## Service Bulletin

#### Subject: Wet Carpet/Floor at Driver and/or Passenger Footwell Areas

### Models: 2010-2014 Chevrolet Equinox 2010-2014 GMC Terrain

2450865

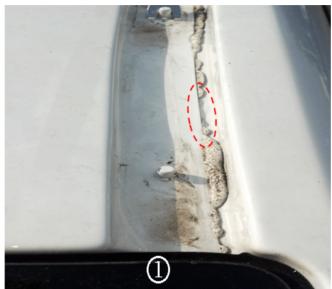
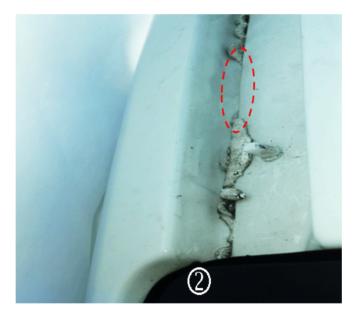
Some customers may comment on finding a wet carpet/floor in the driver or passenger footwell area. This condition may occur due to incomplete or insufficient sealing within the front roof to body side outer panel seams. The condition is most commonly found in the roof ditch within the first 30.5 cm (12 in) rearward from the windshield glass.

If evidence of water is found in these locations, inspect the affected side roof ditch for possible voids in the sealer. Inspect for, and correct this leak, following the repair steps below:

- 2. Inspect for voids/gaps in the seam sealer along the outboard edge of the roof ditch. Examples of this condition are shown in the driver side (1) and passenger side (2) graphics above.
- 3. Clean the affected area and seal all gaps with \*Kent Automotive High-Tech<sup>™</sup> Clear Seam Sealer, P/N 10200 (5 oz tube), or equivalent. Avoid excess sealer build up within the ditch while assuring any voids in the factory seal are filled.
- 4. Allow the seam sealer to adequately set-up, then water test by placing a water hose mid-roof near the ditch, allowing water to run forward to the A-pillar. Visually inspect for any water leaks along the inner roof, A-pillar and floor areas.
- 5. Once the repair is verified, reinstall the roof ditch molding. Refer to Roof Panel Molding Replacement in SI.
- 6. Dry the interior of the vehicle as needed. Refer to Floor Carpet Drying in SI.
